# UNITED STATES PATENT AND TRADEMARK OFFICE

APPLICATION NO.	FILING DATE	FIRST NAMED INVENTOR	ATTORNEY DOCKET NO.	CONFIRMATION NO.
10/709,607	05/18/2004	Ping-Yang Chen	12590-US-PA	3606

<b>Office Action Summary</b>	Application No. 10/709,607	Applicant(s) CHEN ET AL.	
	Examiner Ives Wu	Art Unit 1724

FIG 3A

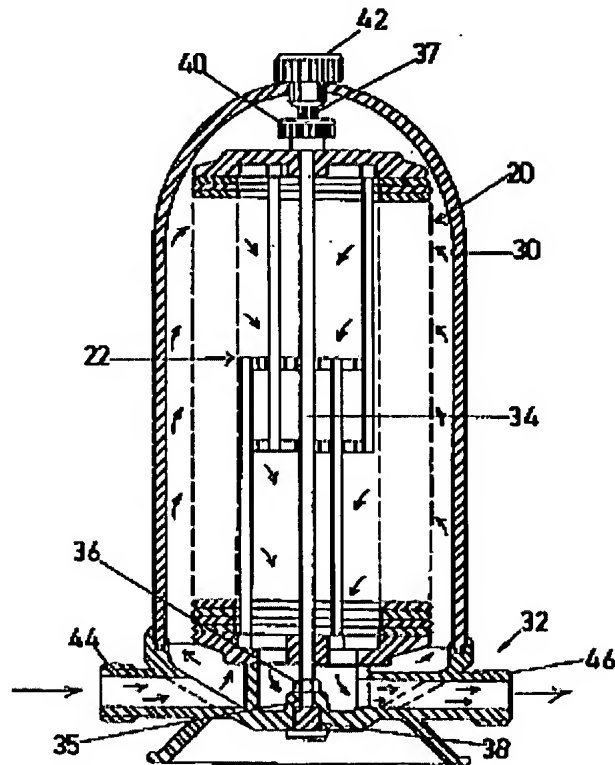
As to a gas inlet, a gas outlet and a hollow interior in a pipe trap body in **independent claim 1**, Drori (US004642182) discloses multiple-disc type filters in a housing shown in Figure 3A, a liquid inlet 44, a liquid outlet 46 and hollow interior between the housing 30 and filtration unit 20.

As to a disc filter set up inside the pipe trap body in **independent claim 1**, Drori discloses multiple disc filter 20 in Figure 3A.

As to a pipe setup inside the pipe trap body with one end linked to the disc filter and the other end linked to the gas outlet, an area on the pipe facing the gas inlet in **independent claim 1**, Drori discloses in Figure 3A, (no number) a section facing the inlet 44 which connects to disc filtration unit 20 at one end, and its other end connects to the outlet 46.

As to limitation of **claim 2**, Drori discloses the base 32, tube body set up on the base such as filtration unit 20 and respective end members, inlet 44, outlet 46 formed on the tube body in Figure 3A.

As to limitation of **claim 3**, Drori discloses the inlet 44 on one side of the housing 30, the outlet 46 is on the other side of the housing, also on the base surface of the housing in Figure 3A. Strauss also discloses outlet 76 on the top surface of the body in Figure 2.

As to limitation of **claim 4**, Drori discloses a central securing rod 34 in Figure 3A set up in the base 32 to mount all filters including mesh separator when the teaching of Strauss is combined.

**Figure 2**

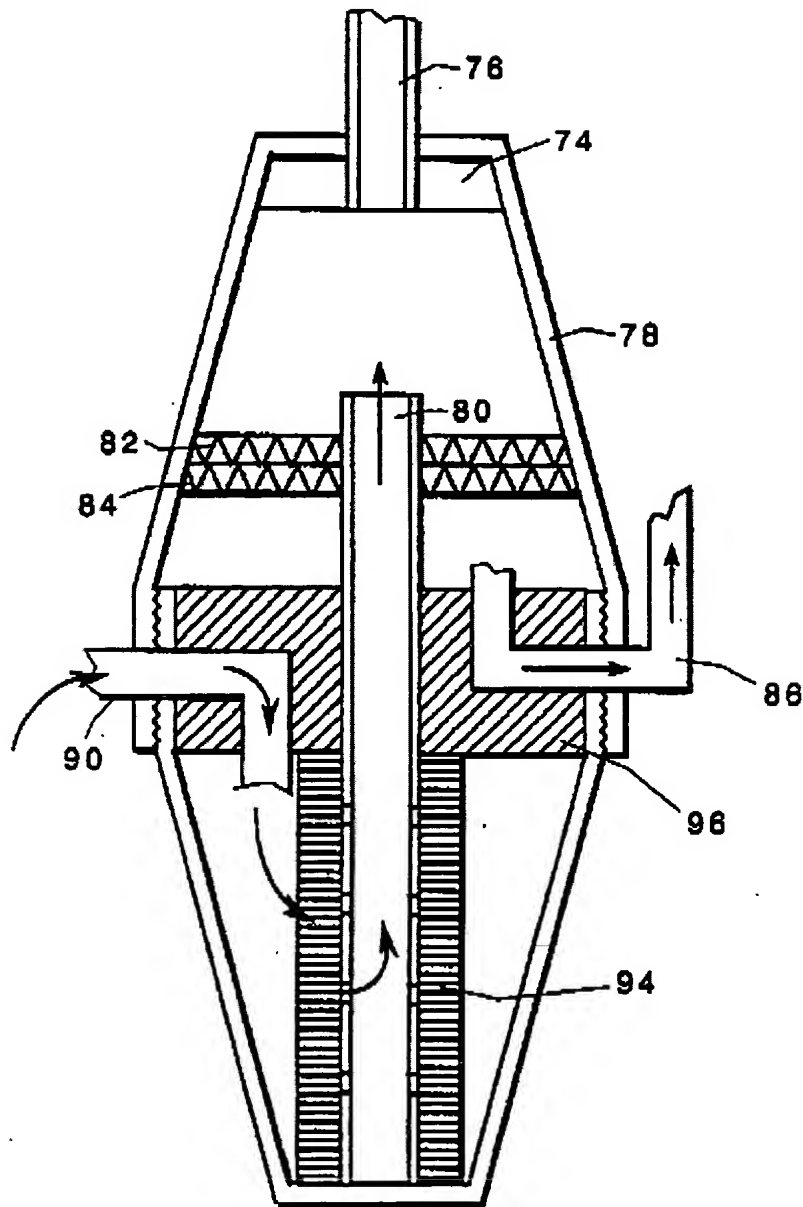
However, Strauss (US005401404) teaches the plastic mesh separator 82 and 84 in Figure 2 in the outlet.

The advantage of adding the mesh separator in the outlet area is to assist to further remove impurity such as oil in the patentee's application.

Therefore, it would have been obvious at time of the invention was made to install further mesh filters of Strauss in the outlet of housing disclosed by Drori in order to obtain the above-mentioned advantage.

As to limitation of **claim 16**, although Strauss does not disclose that different mesh size for 82 and 84 and decreasing mesh size toward the outlet in Figure 2, however, it is well known in the art to arrange the decreasing mesh size filters in the direction of output to get better separation. Therefore, it would have been obvious at time of the invention to put different mesh

size filters taught by Strauss with decreasing size toward the outlet such as the mesh size of 82 to be smaller than the mesh size of 84 in the outlet of Drori in order to obtain the above-mentioned advantage.

**Fig. 3**

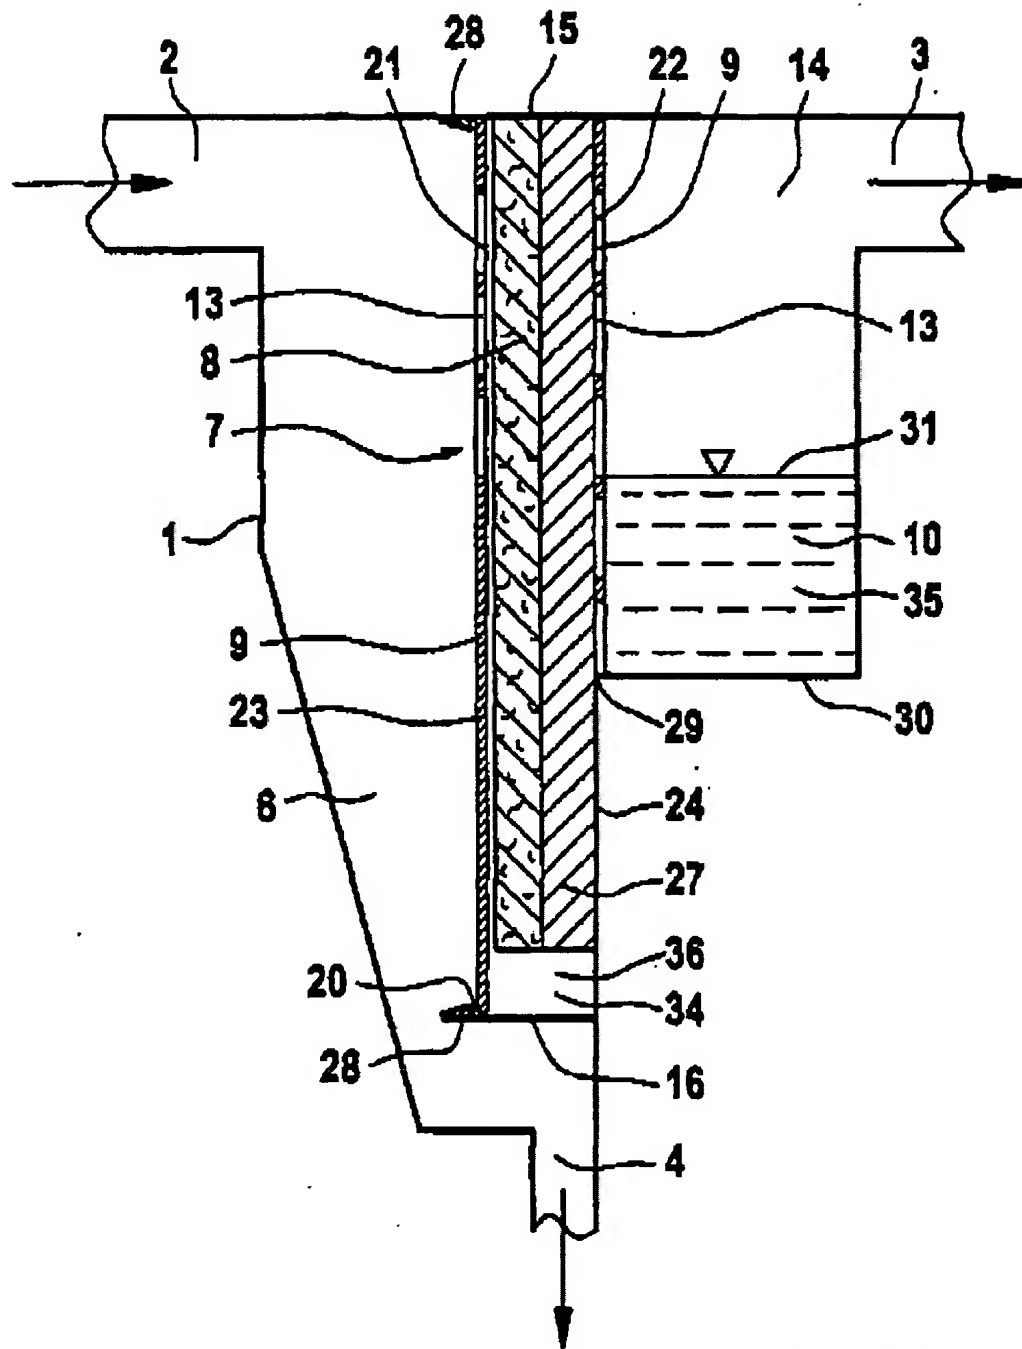
However, Uhlenbrock (US006858051B2) **teaches** the flat wall 7 in Figure 3 for a device of separating a fluid from a gas stream (Title).

The advantage of using flag wall to face the inlet stream is to get greater momentum absorbed on the flat surface than circular surface based on well known concepts of geometry,

then to improve the opportunity for subsequent natural gravitational separation (Col. 3, line 14-18, Lavery et al – US003413778).

Therefore, it would have been obvious at time of the invention to use a planar surface of the pipe disclosed by Uhlenbrock for the pipe of Drori in order to acquire the better efficiency as above-mentioned.
